Addendum No. 1

Bid Opportunity: 7159-RW-22 – Smithson PS Office and HVAC Upgrades.

Closing Date: Monday, March 14th, 2022 2:00 PM

Drawn By **DB** Scale **As Shown**
 Designed By **DB** Date **November 26, 2020**
 Project Number **B20-349.02A**
 Sheet Number **E1** Revision **1**

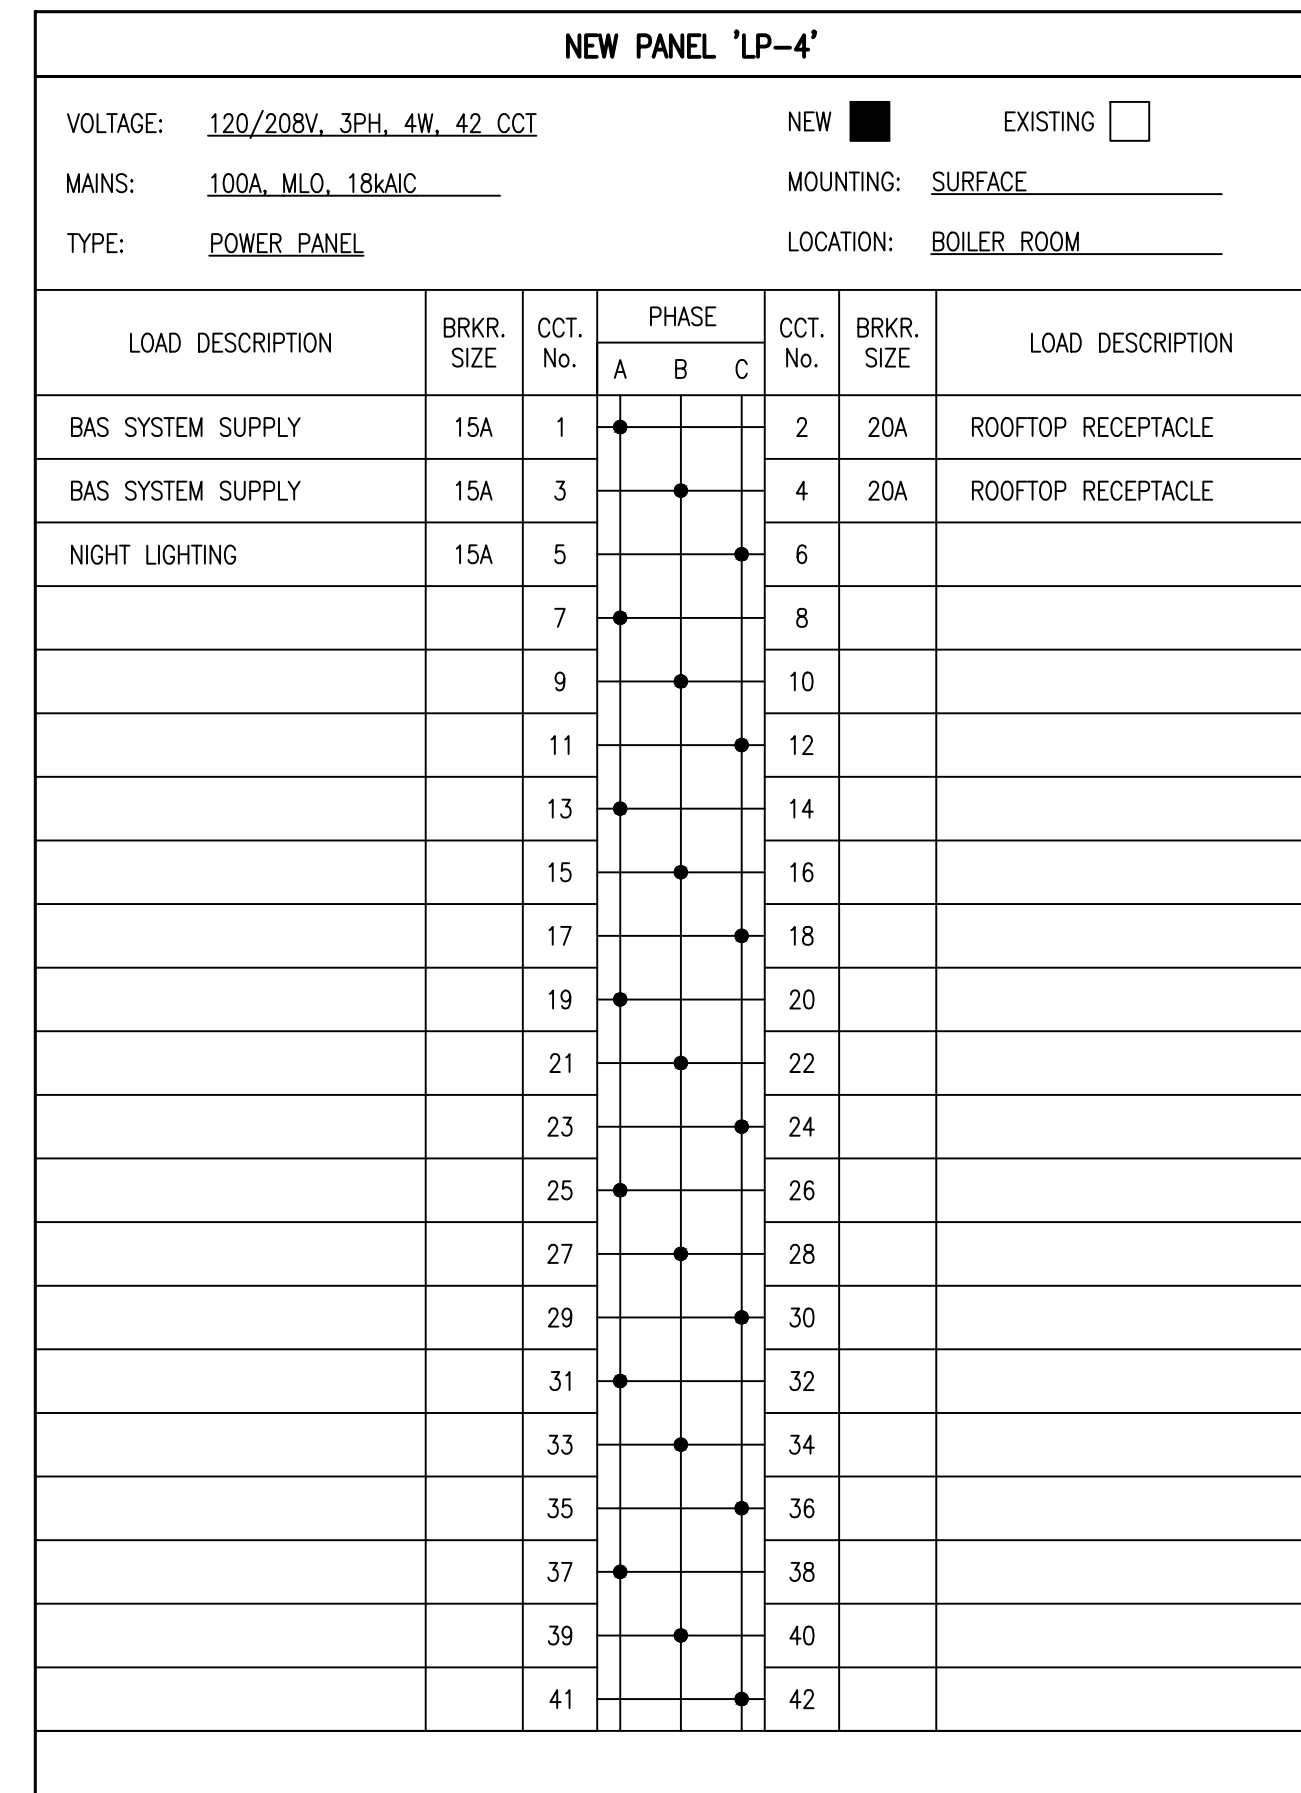
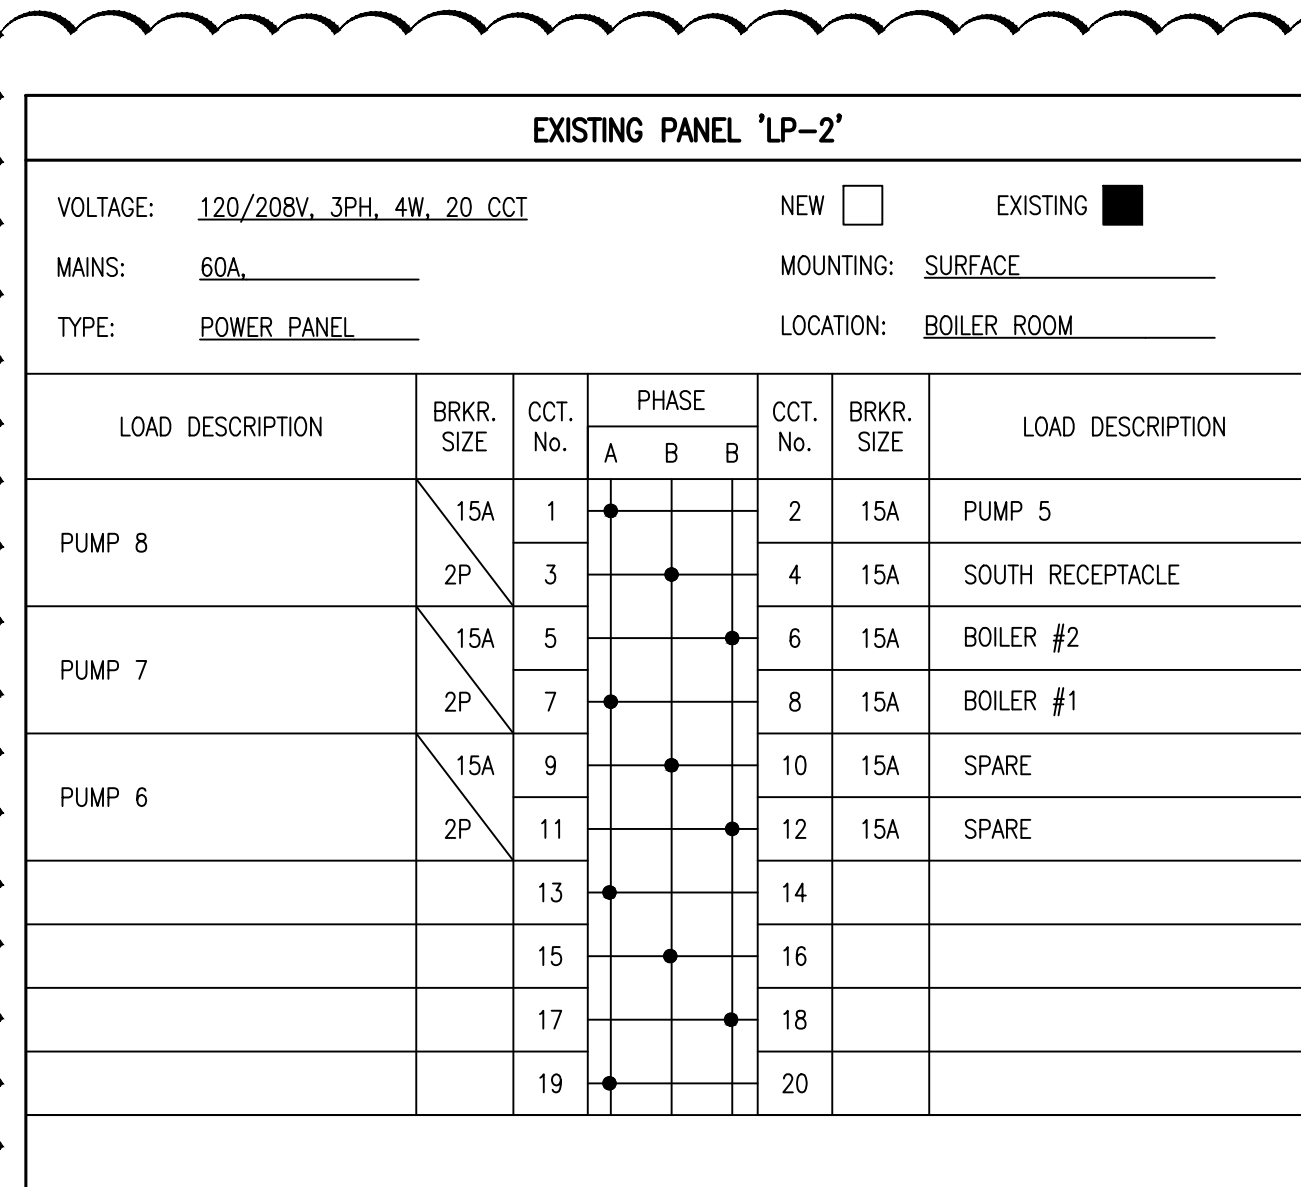
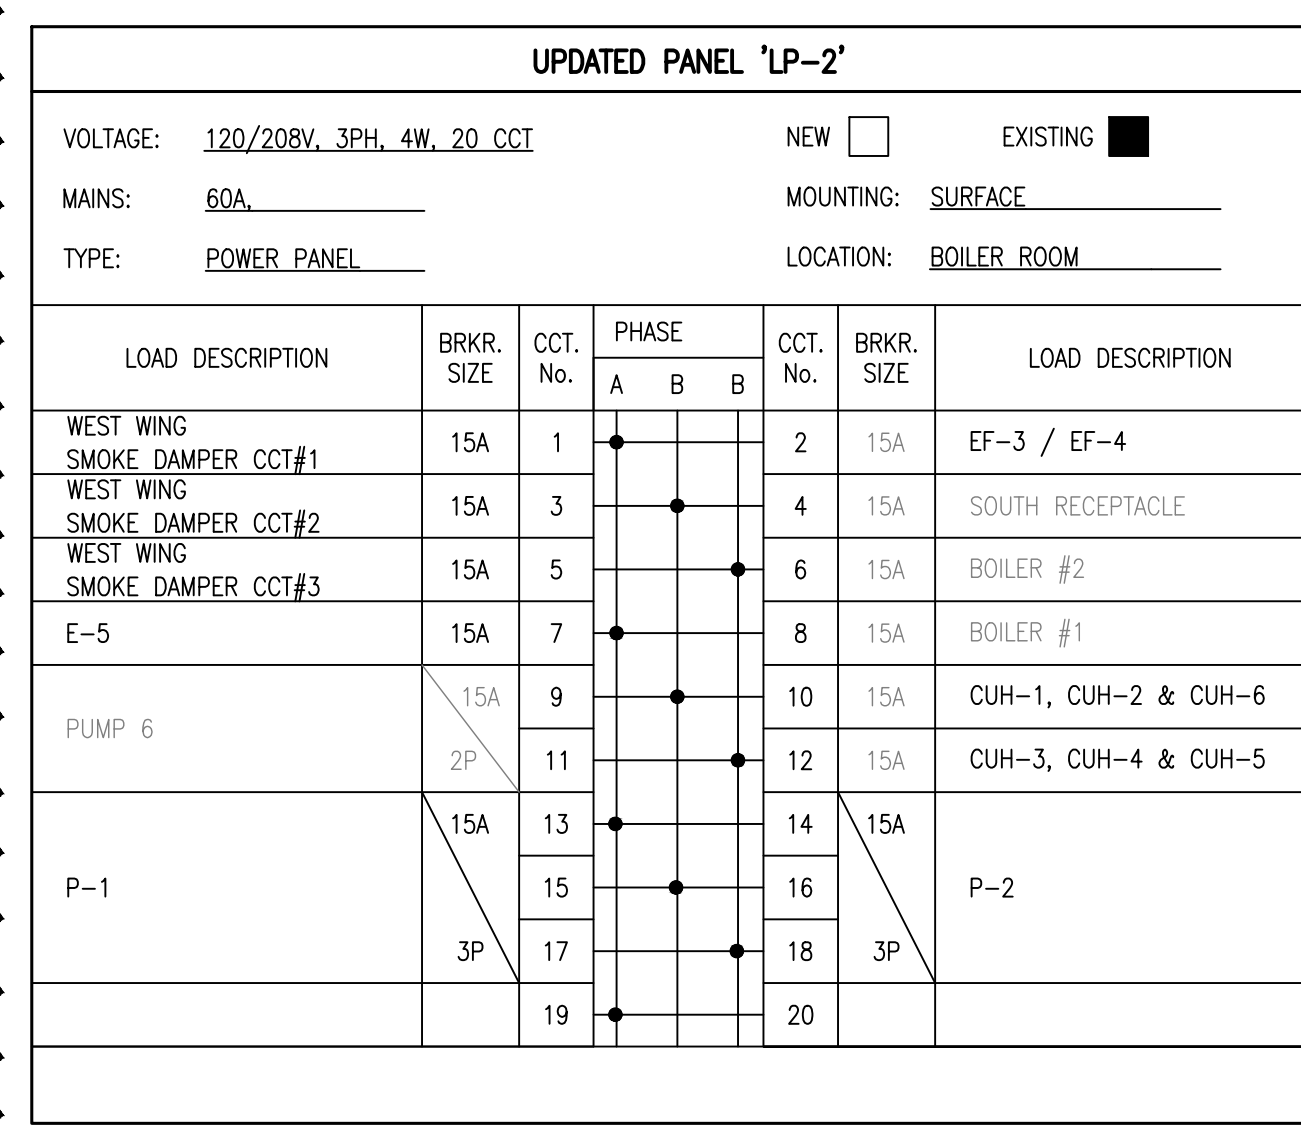
**2. REFERENCE DRAWING E1 – ELECTRICAL LEGEND AND SCHEDULES
(ISSUED FOR ADD-E01)**

1. The breaker size for rooftop unit HVAC-2, has been revised from 600V,25A,3P to 600V,20A,3P to match the latest requirements from the mechanical design.
2. The breaker size for rooftop unit HVAC-3, has been revised from 600V,25A,3P to 600V,20A,3P to match the latest requirements from the mechanical design.
3. The breaker size for rooftop unit HVAC-5, has been revised from 600V,25A,3P to 600V,20A,3P to match the latest requirements from the mechanical design.
4. The circuit breakers SWB#A10 and SWB#A11 have been removed. The pumps P-1 and P-2 will now be 208V, fed from panel LP-2.
5. A Panel schedule for new panel LP-4 has been added.
6. The panel scheduleS for LP-2 has been revised to an existing and updated panel schedules to show the scope of work regarding demolition of existing breakers and installation of new breakers within the existing to remain panel.
